**VIRGINIA ELECTRIC AND POWER COMPANY  
RICHMOND, VIRGINIA 23261**

**May 6, 2010**

Serial No.	10-199
NL&OS/GDM	R1
Docket Nos.	50-280, 50-281
License Nos.	DPR-32, DPR-37

**VIRGINIA ELECTRIC AND POWER COMPANY (DOMINION)**  
**SURRY POWER STATION UNITS 1 AND 2**  
**LICENSE AMENDMENT REQUEST**  
**REVISED CUMULATIVE CORE BURNUP APPLICABILITY LIMIT FOR HEATUP AND**  
**COOLDOWN CURVES, LOW TEMPERATURE OVERPRESSURE PROTECTION SYSTEM**  
**(LTOPS) SETPOINT, AND LTOPS ENABLE TEMPERATURE**

Figure 3.1-1 : Surry Units 1 and 2 Reactor Coolant System Heatup Limitations (Heatup Rates up to 60°F/hr) Applicable for the first ~~28.8~~ <sup>48</sup> EFY for Surry Unit 1 and the first ~~29.4~~ <sup>48</sup> EFY for Surry Unit 2

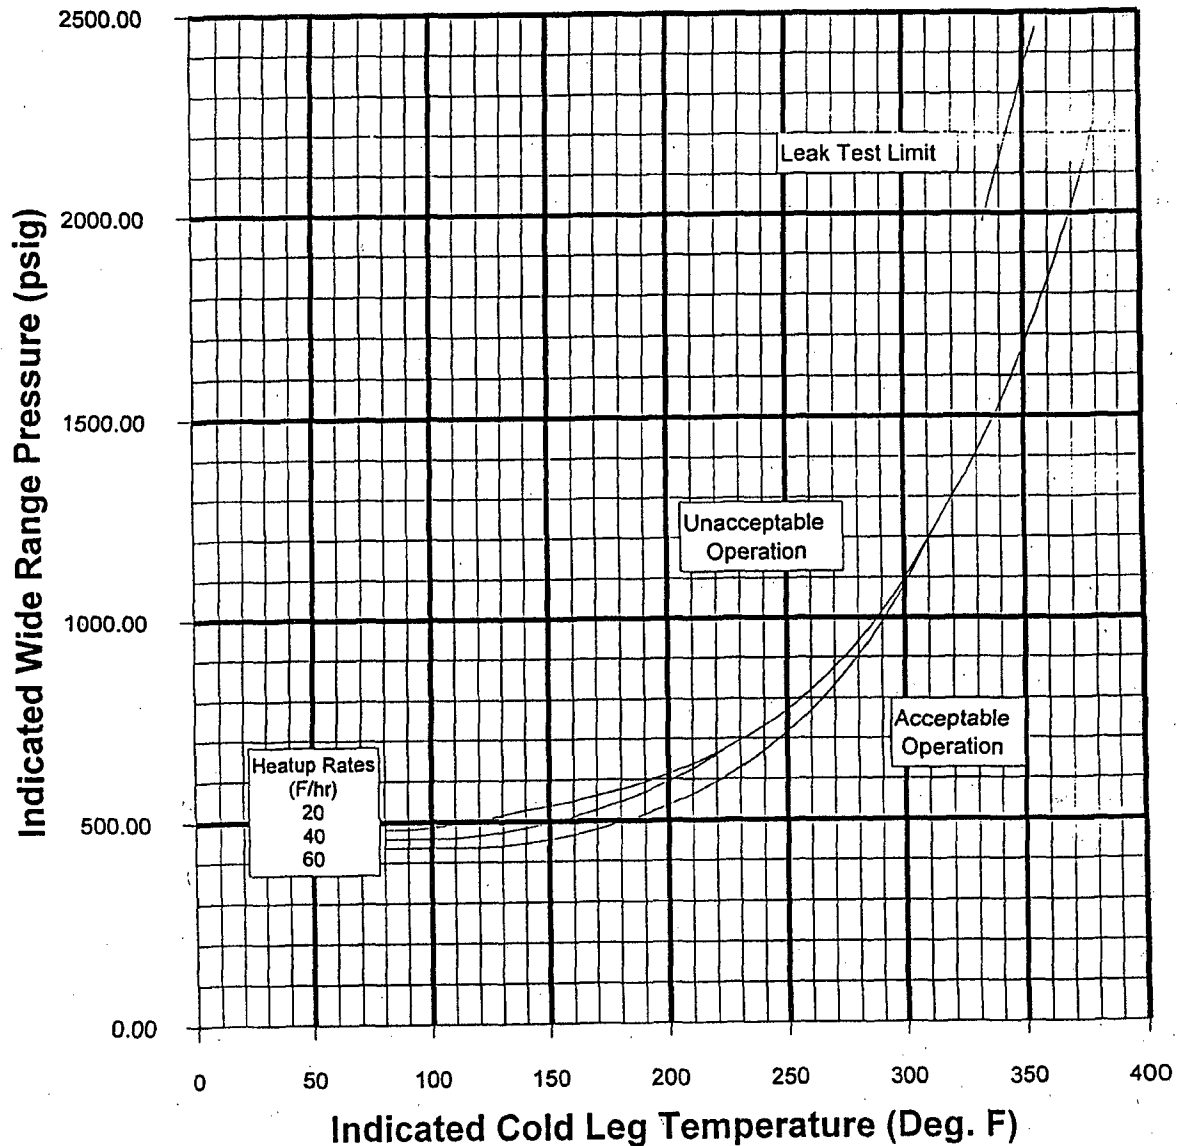
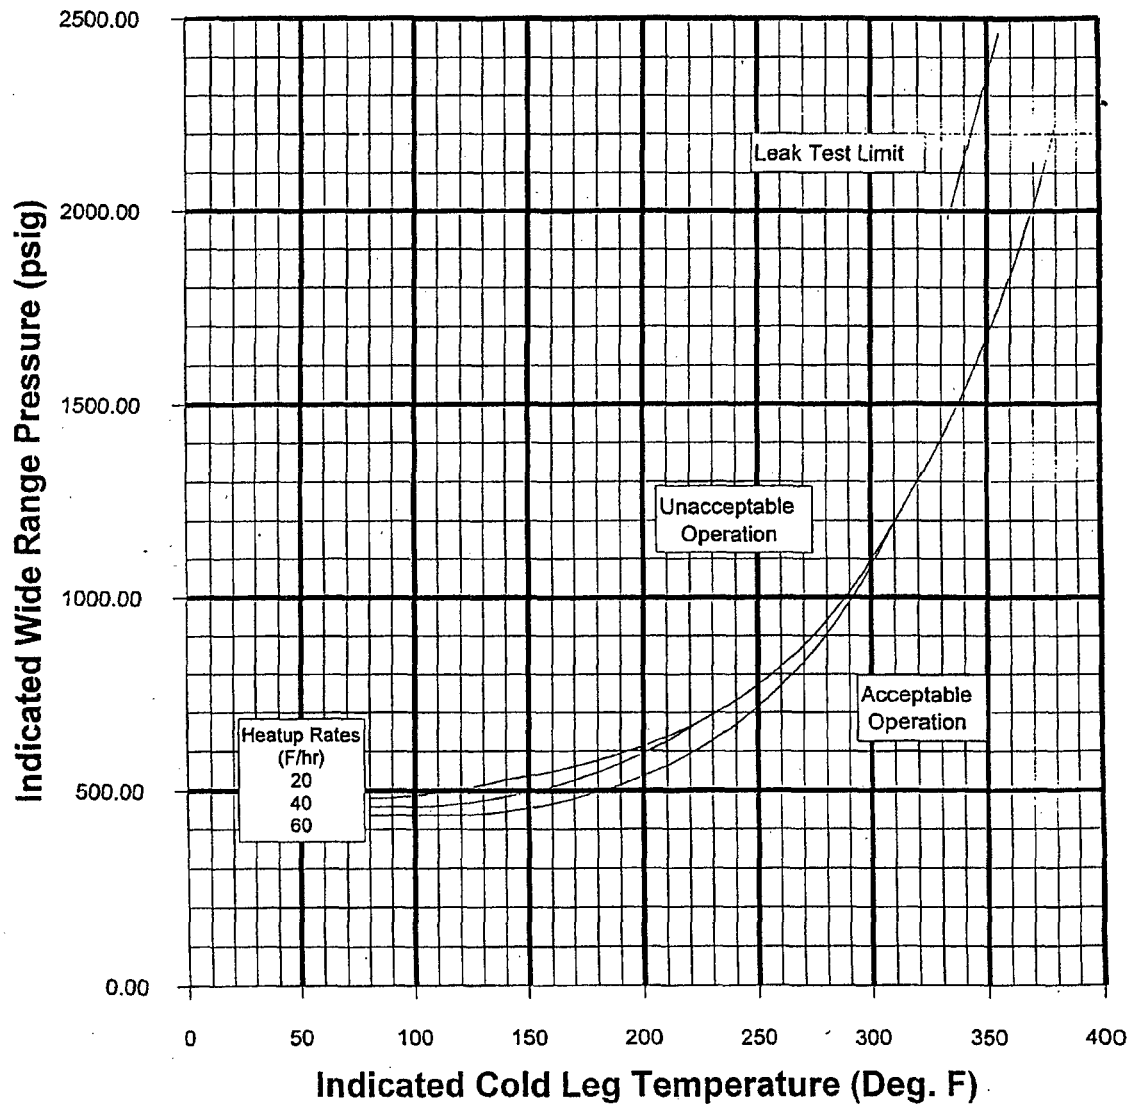
- Modify Surry Units 1 and 2 Reactor Coolant System Heatup and Cooldown Limitations, Figures 3.1-1 and 3.1-2, respectively, to reflect a cumulative core burnup applicability limit of 48 EFPY.

Material Property Basis  
 Limiting Material: Surry Unit 1 Intermediate to Lower Shell Circ Weld  
 Limiting ART Values for Surry 1 at ~~28.8~~ <sup>48</sup> EFY: 1/4-T, 228.4F  
 3/4-T, 189.5 F

Limiting ART Values for Surry 1 at 48 EFPY: 1/4-T, 228.4F

Figure 3.1-1 : Surry Units 1 and 2 Reactor Coolant System Heatup Limitations  
(Heatup Rates up to 60°F/hr) Applicable for 48 EFPY

Figure 3.1-2 : Surry Units 1 and 2 Reactor Coolant System Cooldown Limitations  
 (Cooldown Rates up to 100°F/hr) Applicable for the first 28.8 EFY for  
~~Surry Unit 1 and the first 29.4 EFY for Surry Unit 2~~ 48

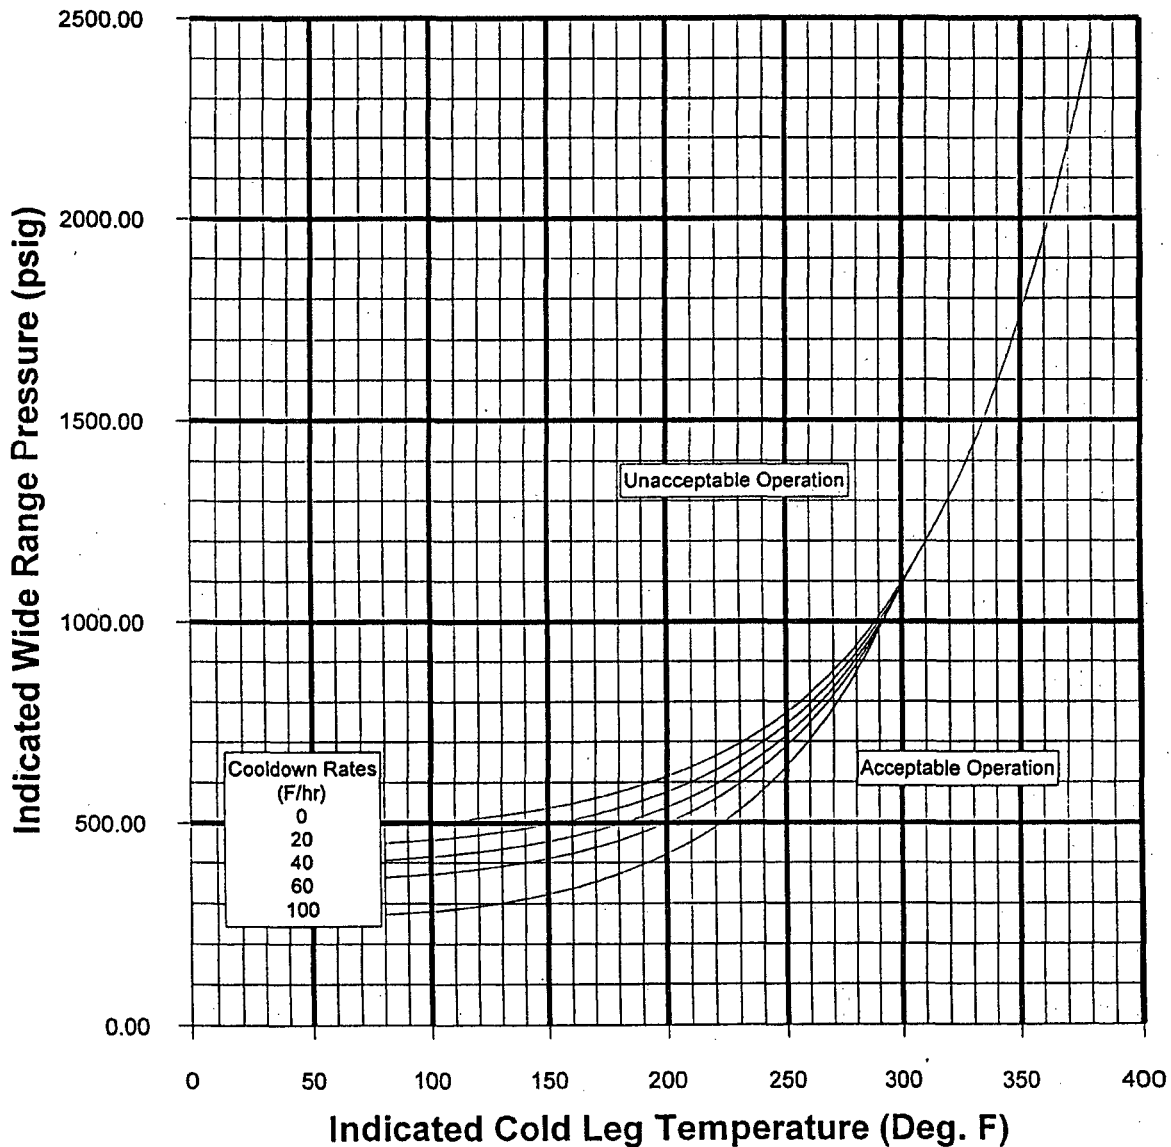
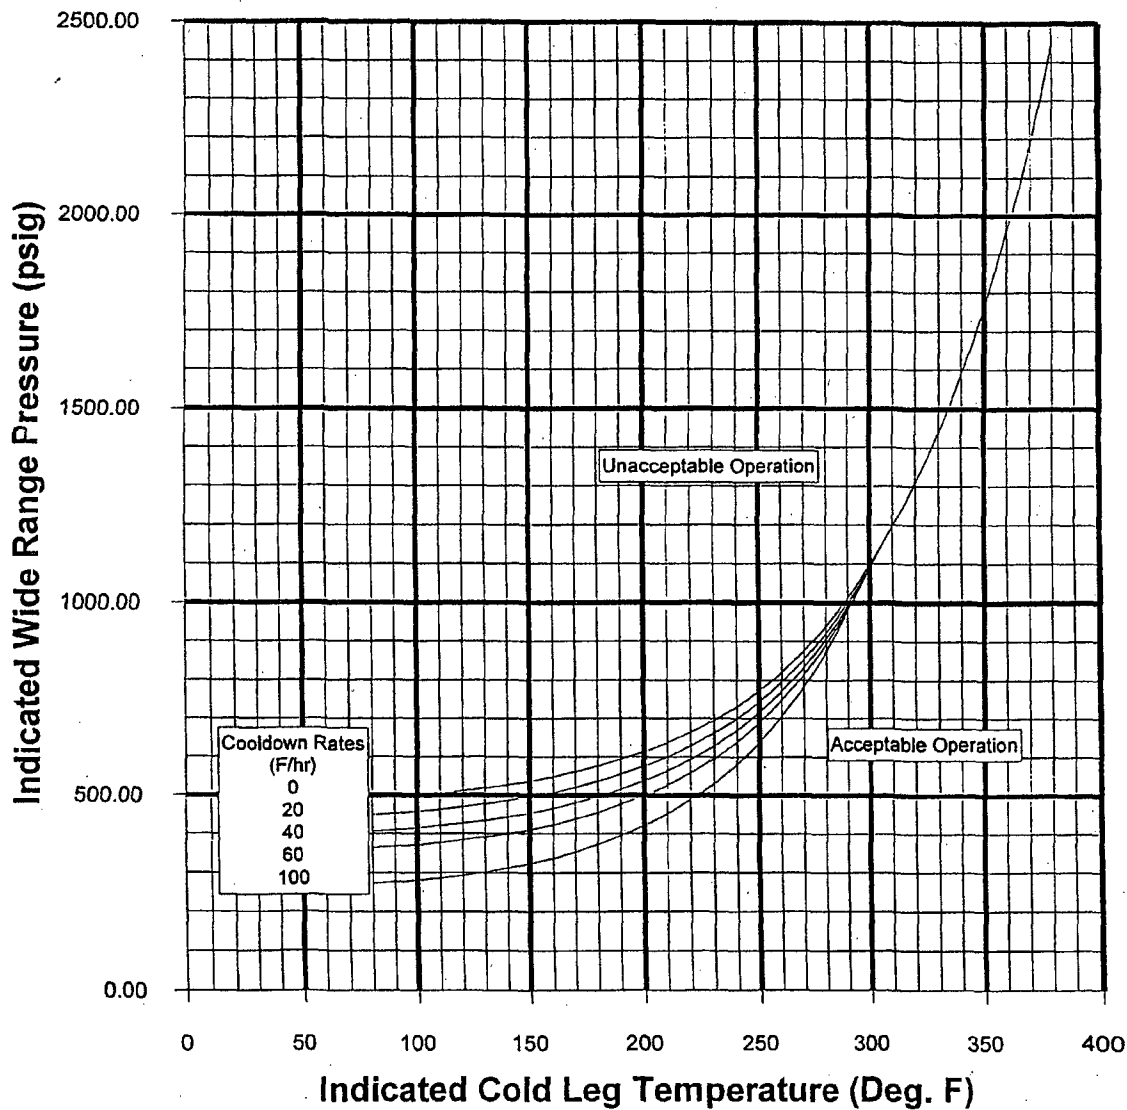
Material Property Basis  
 Limiting Material: Surry Unit 1 Intermediate to Lower Shell Circ Weld  
 Limiting ART Values for Surry Unit 1 at 28.8 EFY: 1/4-T, 228.4F  
 3/4-T, 189.5 F

Limiting ART Values for Surry 1 at 48 EFPY: 1/4-T, 228.4F

Figure 3.1-2 : Surry Units 1 and 2 Reactor Coolant System Cooldown Limitations  
(Cooldown Rates up to 100°F/hr) Applicable for 48 EFPY
